CITROËN CARS CORPORATION

INDEX TO TRANSMISSIONS / DRIVESHAFTS

SERVICE BULLETIN #66

**DS 19 TRANSMISSION
SECOND GEAR AND REVERSE PATIOS**

SUBJECT: TRIPOD DRIVE SHAFT

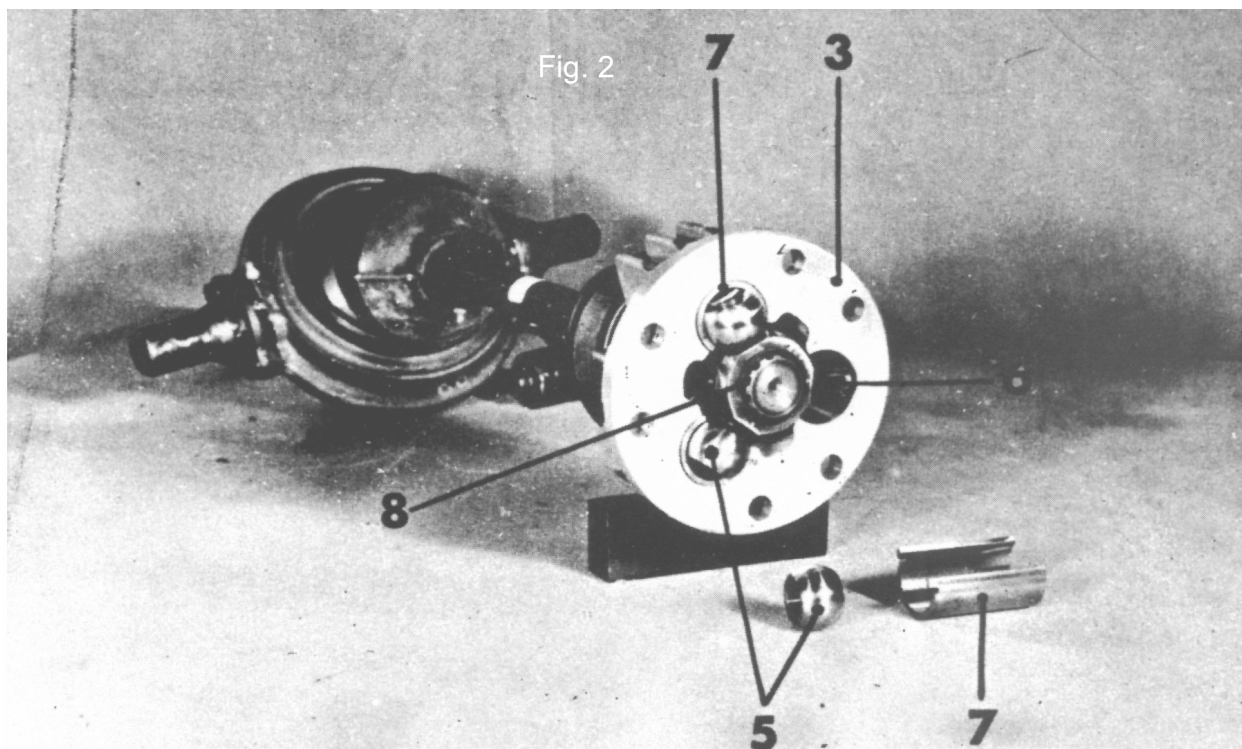
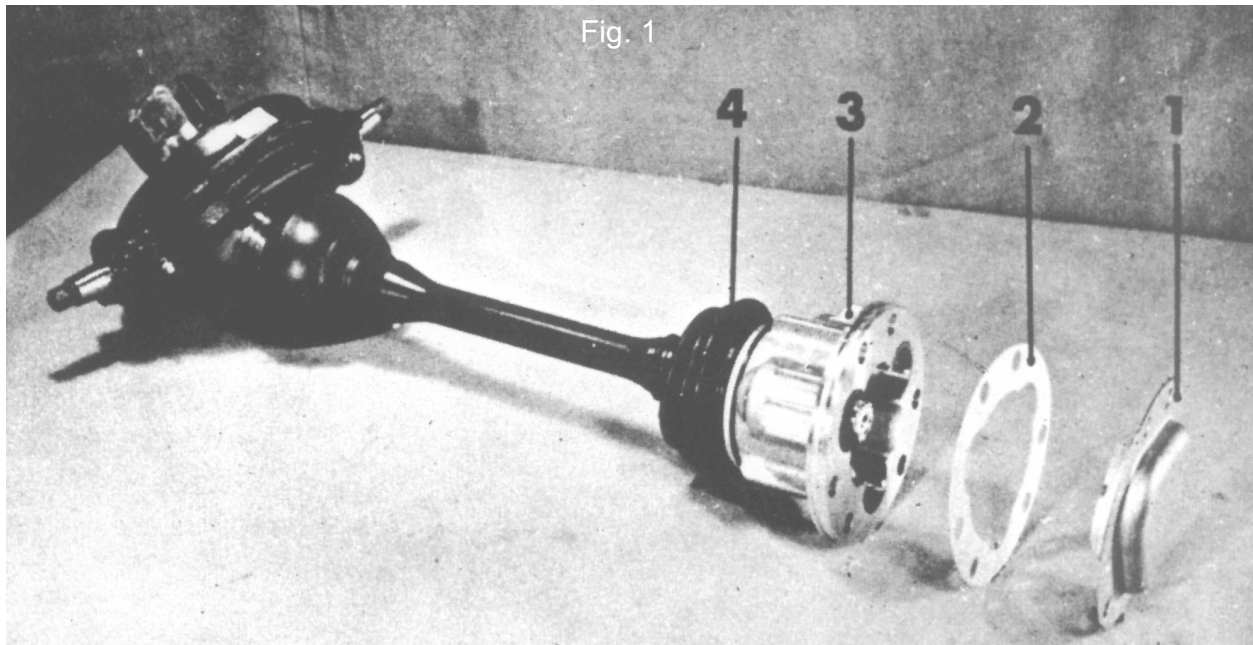
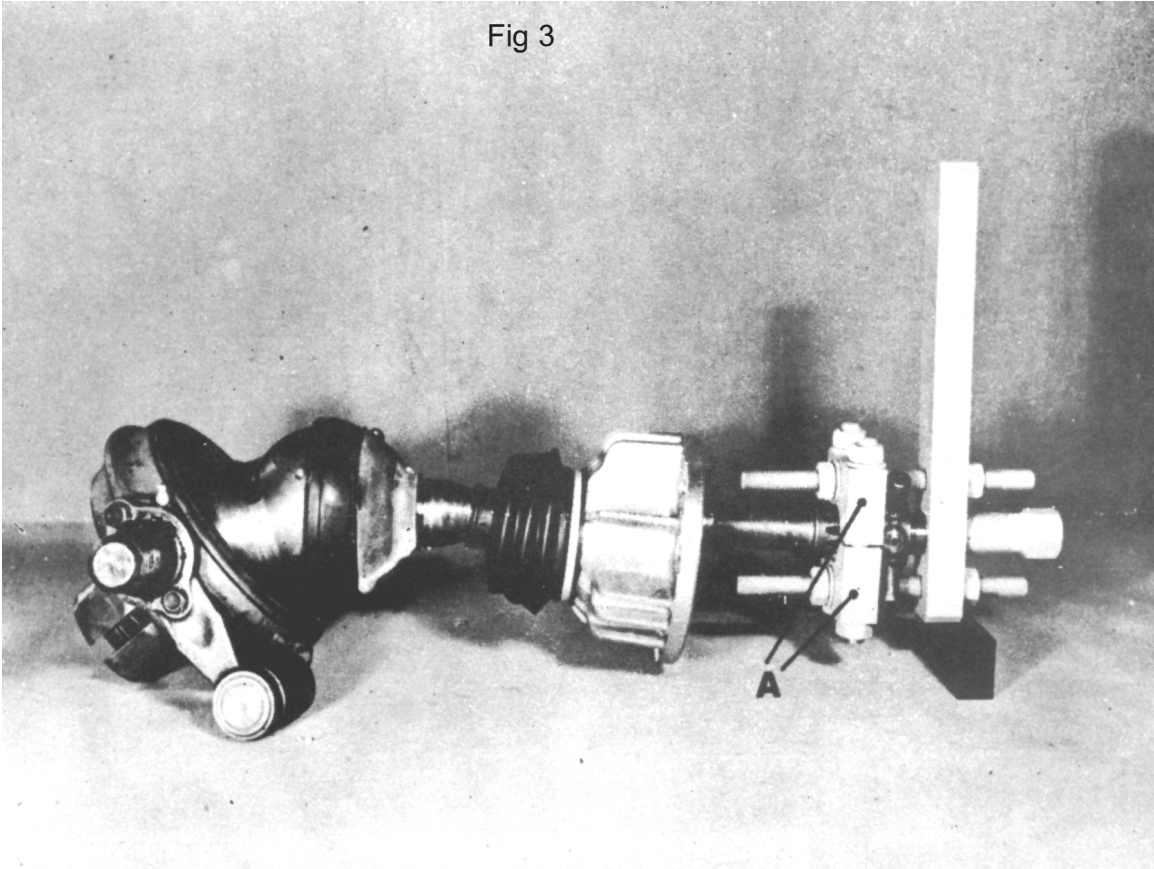
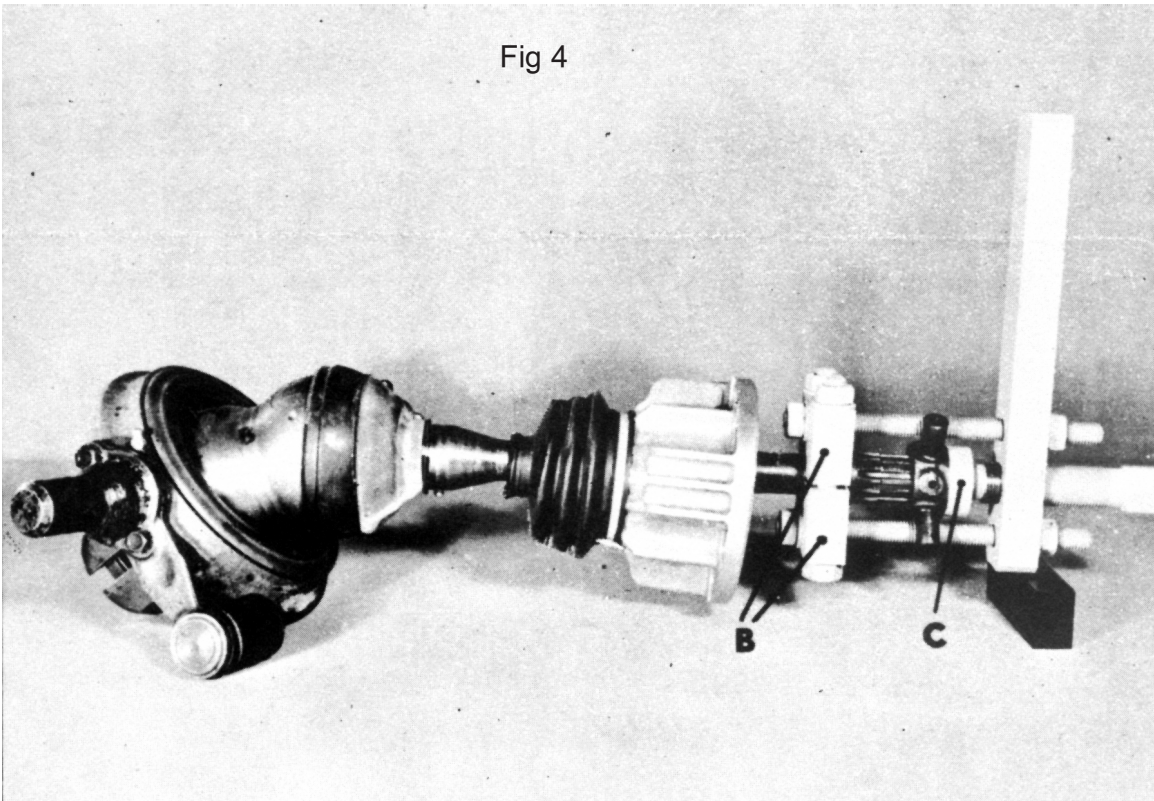
- Remove the drive shaft
- Remove the cover plate (1 fig.1) and gasket (2 fig.1) from the "tripod" housing
- Remove the rubber boot clamp (4 fig.1) from the shaft and housing
- slide the housing (3) from the studs. This will permit removal of the balls from the pins (6 fig.2)
- Using a hook, remove the ball sleeves (7 fig.2) from the housing (3). These should slide out freely.
- Remove the circlip (8 fig.2)

- Extract the "tripod" (6) using the extractor I93I T, complete with yoke (A fig.3)
- Remove the housing (3) and the rubber boot (4)

- Replace the rubber boot (4) and the housing (3) on the drive shaft
- Replace the "tripod" (6) using extractor I93I T, with yoke B and thrust block G (fig.4)
- Push the tri-axis against the stop shoulder
- Replace the circlip (8)
- Assemble the ball sleeves (7) to the housing (3)
- Replace the balls (5) on the tri-axis (6)
- Using 7 oz. of premium bearing grease, carefully coat the tripod balls, the sleeves and pack the housing interior

The nuts which mount the "tripod" housing to the differential flange should be tightened to 62-80 ft/lbs.

M A I N S H A F T

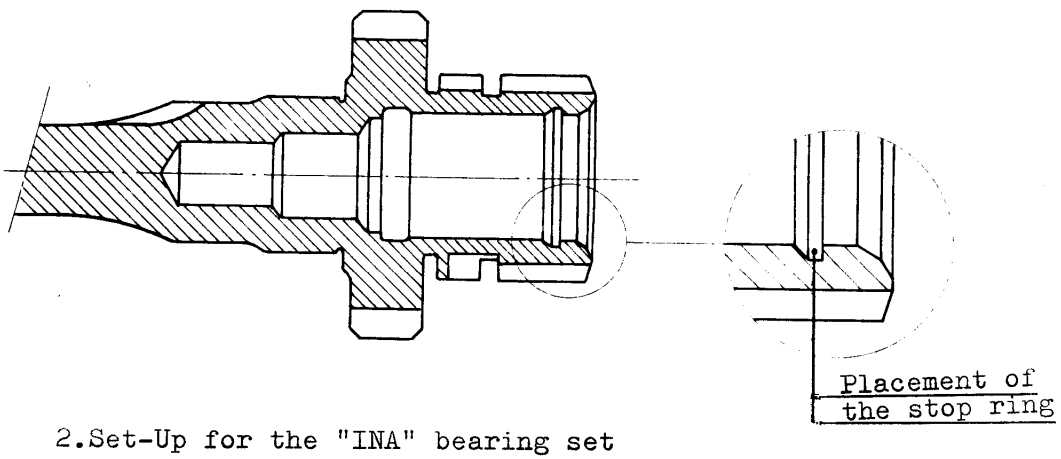
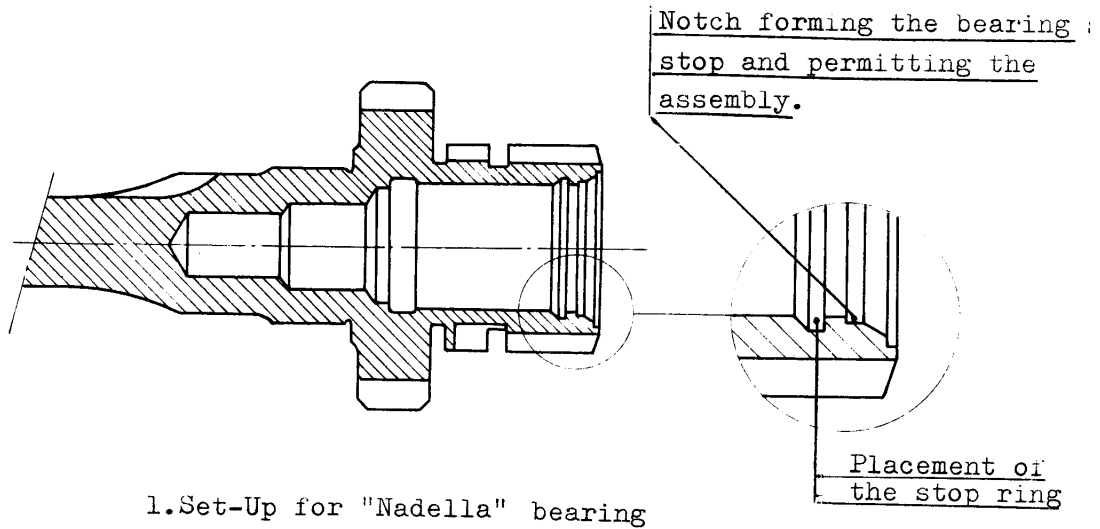
The "NADELLA" type needle bearing and lock ring sold as an assembly under part No. 4176 S are replaced by an "INA" type bearing, part No. 620232 and a stop ring No. 620534.

The groove, machined in the shaft, at the entrance of the bore designed to seat the "NADELLA" bearing, is replaced by a chamfer which facilitates mounting of the stop ring No. 620534 (see figure).

It is possible to mount the "INA" bearing in a shaft having a groove. Be sure the stop ring seats well in the groove after mounting.

It is not possible to mount a "NADELLA" bearing in a new shaft having only a chamfer.

Modification of the spanner 1920-T

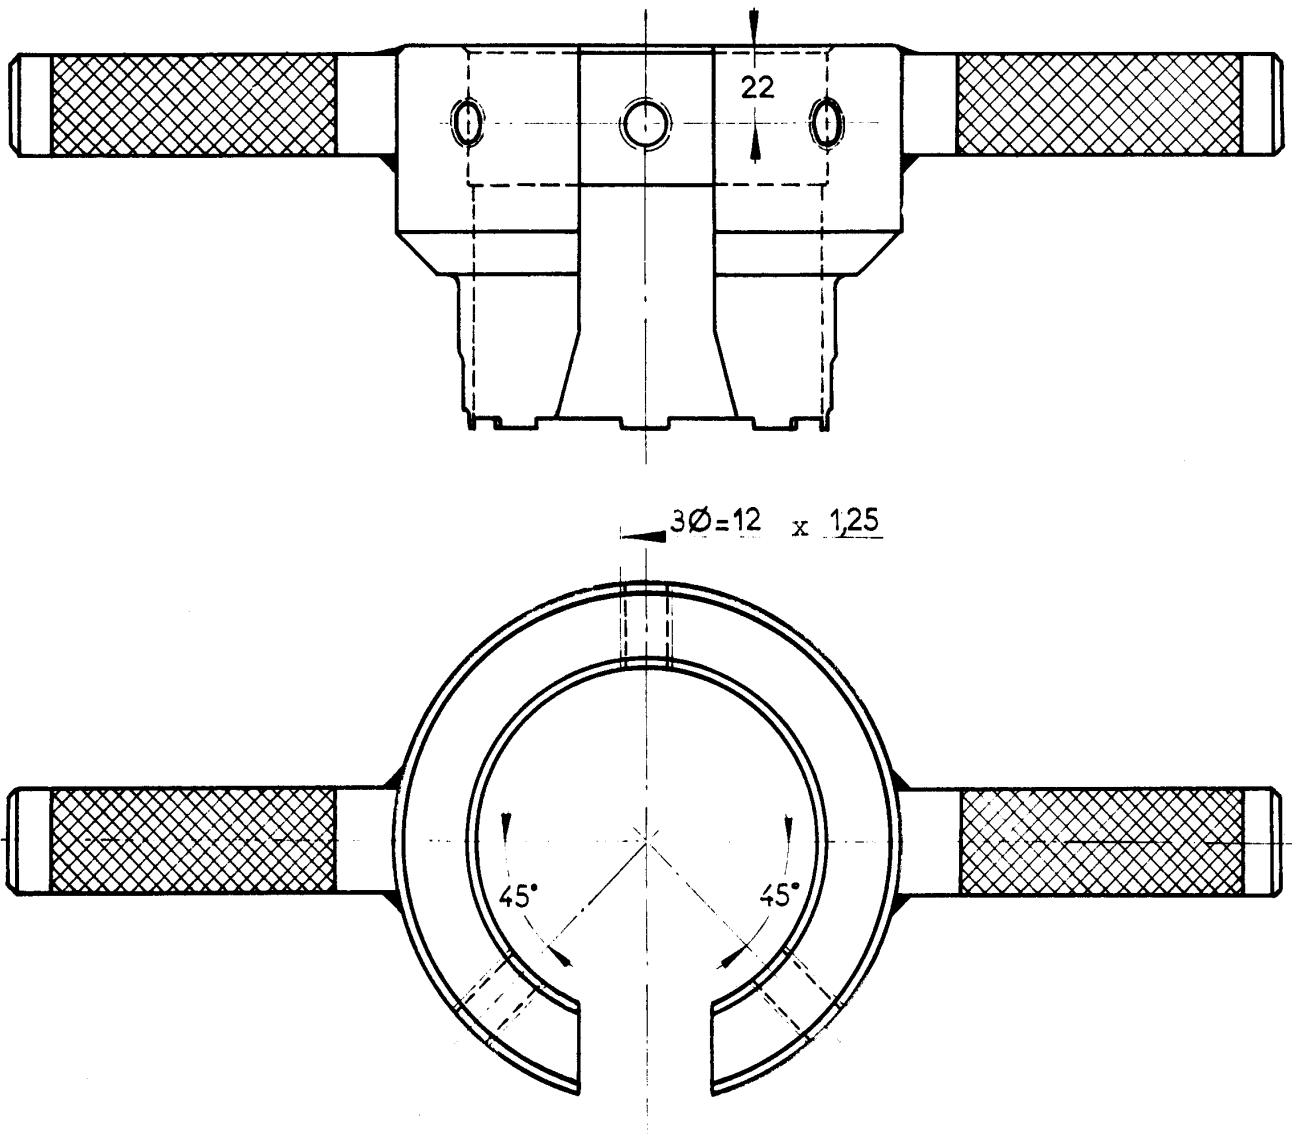
The torque applied to the ring nut coupling the driveshaft to the pivot has been changed from 40 to 55 +5/-0 m.kg (290 to 400 ft/lbs)

The spanner sold as I920-T has been replaced by the spanner 1925-T. However, it is possible to modify tool I920-T for use in emergencies; proceed as follows:

- 1) Replace the arms by two new arms of tough tool steel 30 mm. diameter forced on and welded.
- 2) Drill and tap 3 holes 12 mm x 1.25 (see figure) and place therein 5 screws (DS 451-103B) having the threaded end ground to a point of 600.
- 3) Use the spanner as indicated in operations DS or ID 372-1 of the Shop Repair Manuals but bring the three screws in contact with the driveshaft before turning the spanner and back off the screws as soon as the ring nut is locked or unlocked (screws are used as guides only).

Fig 2

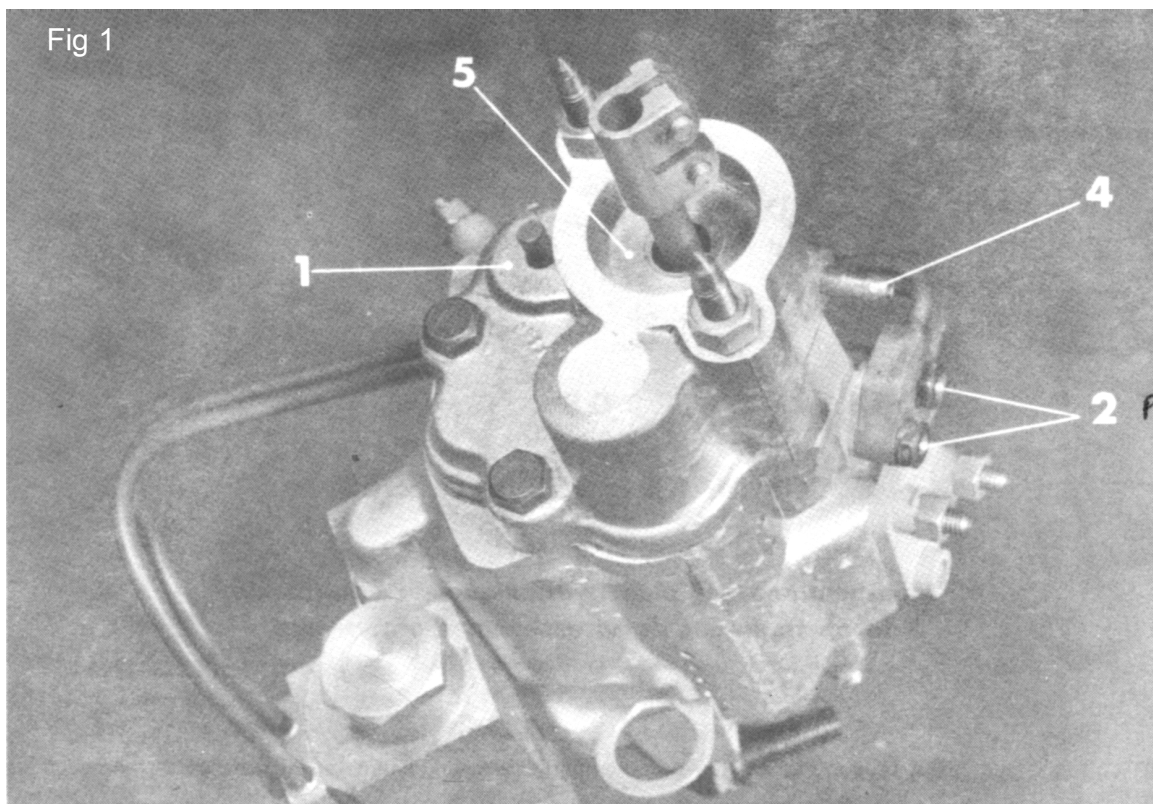
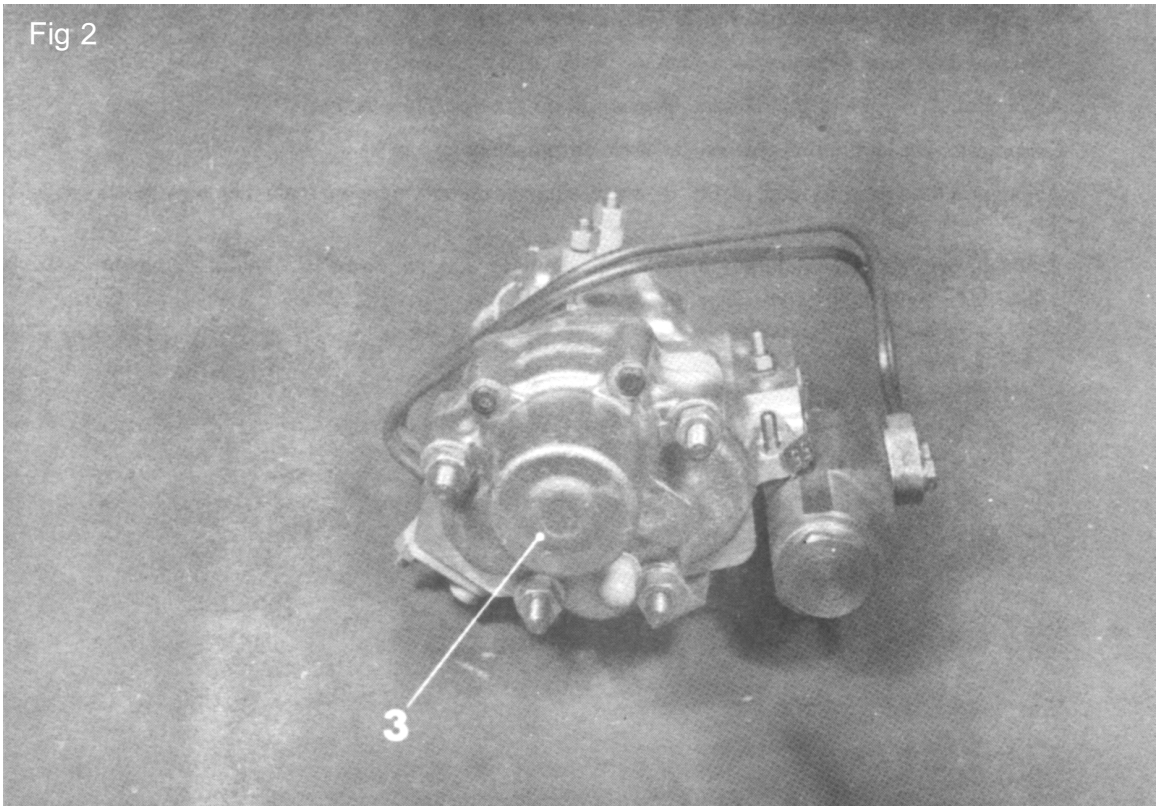
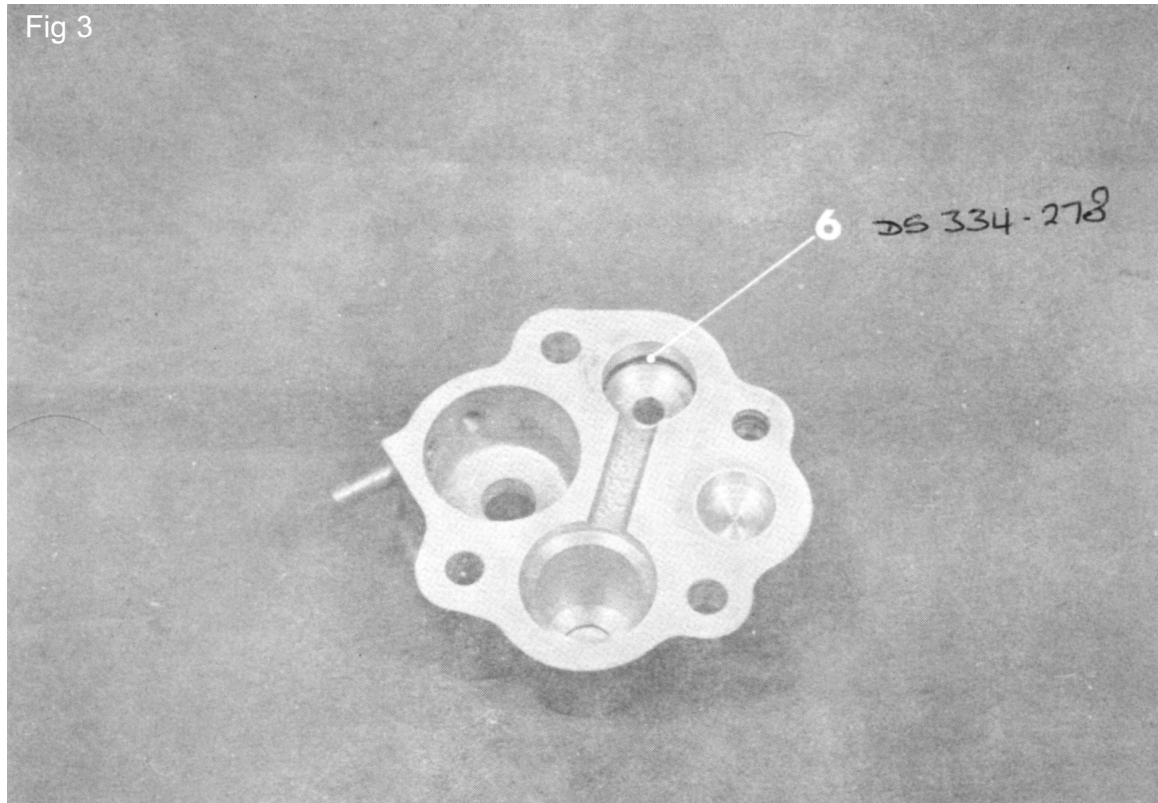
- Creation of an exterior casting embossment at the location of the manual clutch control valve (1 fig.1)
- Replacement of the two studs fastening the shift corrector tubes by two screws (2 fig.1)
- Fastening the front cover (3 fig.2) at six points instead of four.
- Mounting of a leakage drain tube (4 fig.1) on the rear cover.
- Addition of a partition cast (5 fig.1) in the passage of the gear selector valve.
- Abolition of the seal between the sleeve and the gear selector valve.
- Addition of the seal ring (6 fig.3) between the manual clutch control housing and the rear cover.
- The end plug of the automatic clutch control pistons housing is of steel (instead of aluminum) mounted with a sliding fit in the housing.

SUBJECT: GEAR BOX Improvement - 3rd Speed Engagement

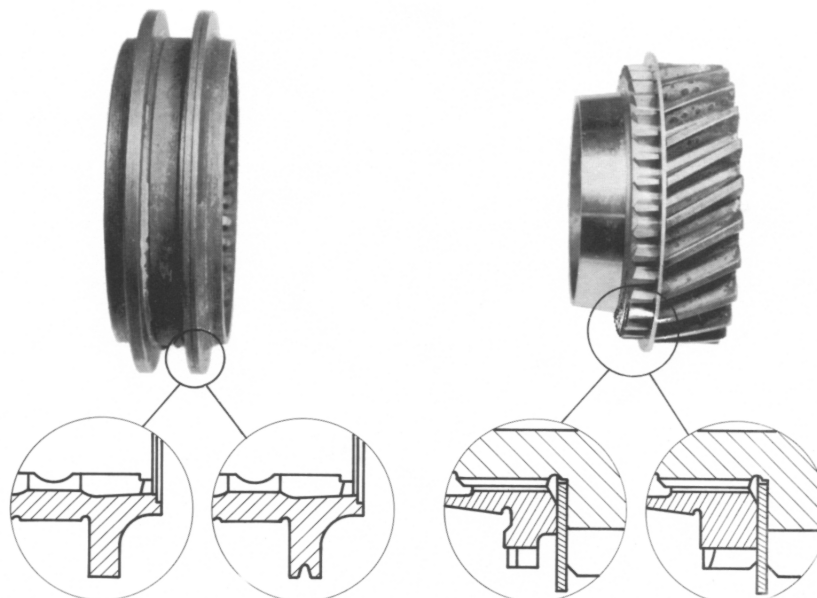
The 3rd and 4th speed synchronizer, as well as the 3rd speed pinion have been modified. The form of the engagement teeth on both pieces has been changed.

- 1) The synchronizer has a groove on the collar facing 3rd speed.
- 2) The engagement teeth of the 3rd speed pinion are longer than those of the former pinion. On the former pinion a groove exists between the engagement teeth and the washer placed between these teeth and the teeth of the pinion. This groove has been eliminated in the new part.

The new synchronizer, DX 335-06a, and the new 3rd speed pinion, DX 333-8b, must necessarily be mounted as an assembly. It is not possible to mount one of the new parts with either of the old parts.
